## **City of Raleigh**

**Request for Bids #:** 274 ES 2023-05R-1

**Title:** Wake BRT New Bern Avenue Construction Package 1

### **ADDENDUM NO. 2**

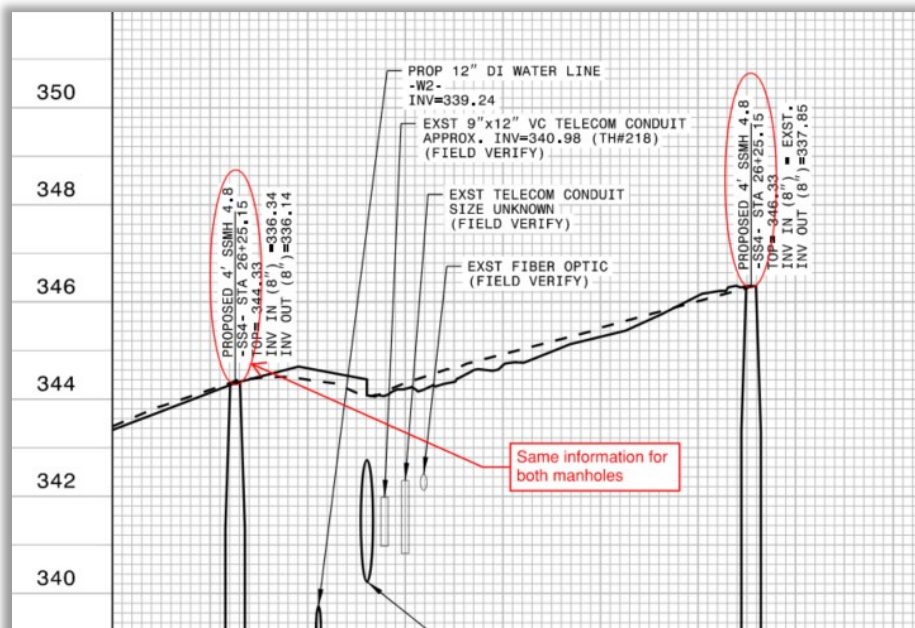
- **Question:** See snippet below, some duplicated info, the SSMH on the right is surely 4.9 but probably should be fixed.

**Answer:** Utility Betterment Plans have been revised.
